Subject: UniStar Nuclear Energy, NRC Docket No. 52-016  
Response to Request for Additional Information for the  
Calvert Cliffs Nuclear Power Plant, Unit 3,  
RAI No. 99, Probable Maximum Tsunami Flooding, Questions 02.04.06-10,  
02.04.06-12 through 02.04.06-17

**Response to NRC Request for Additional Information RAI No. 99,  
Question 02.04.06-10, 02.04.06-12 through 02.04.06-17,  
Probable Maximum Tsunami Flooding, Calvert Cliffs Nuclear Power Plant, Unit 3**

**RAI No. 99**

**Figure 2.4-38 - {Time History of Tsunami Water Levels at The Site, Case 2, Cases 1 through 3, Linear Model}**

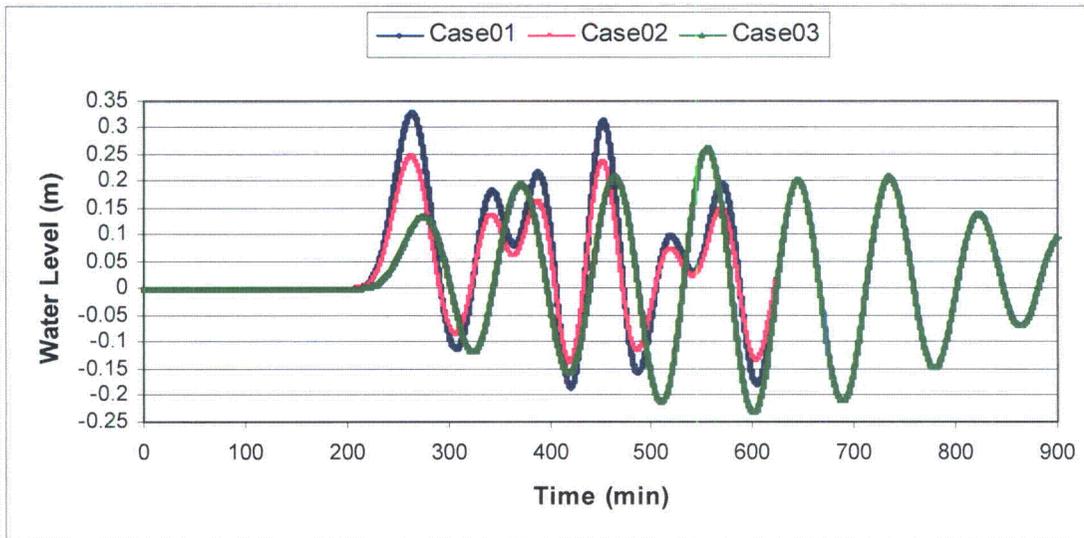
Figure 2.4-38 will be replaced as follows in a future version of the COLA. For clarity, only the revised figure is shown.

Variations in simulated water levels with time at the CCNPP Unit 3 site for the selected tsunami scenarios are shown in Figure 2.4-37 and Figure 2.4-38. These results show that the maximum tsunami amplitude at the CCNPP Unit 3 site is associated with Case 1, the Norfolk Canyon submarine landslide scenario, while the maximum tsunami drawdown that would occur is associated with Case 3, the Haitian earthquake scenario. Both maximum tsunami amplitude and drawdown were obtained with the linear (TSU) model. As shown in Table 2.4-28, the maximum tsunami amplitude and drawdown elevations at the CCNPP Unit 3 site are 1.07 ft (0.326 m) and 0.78 ft (0.237 m), respectively, as referenced to MSL. The results indicate that the linear solution of the shallow water equations provides bounding estimates of tsunami amplitude and drawdown at the CCNPP Unit 3 site.
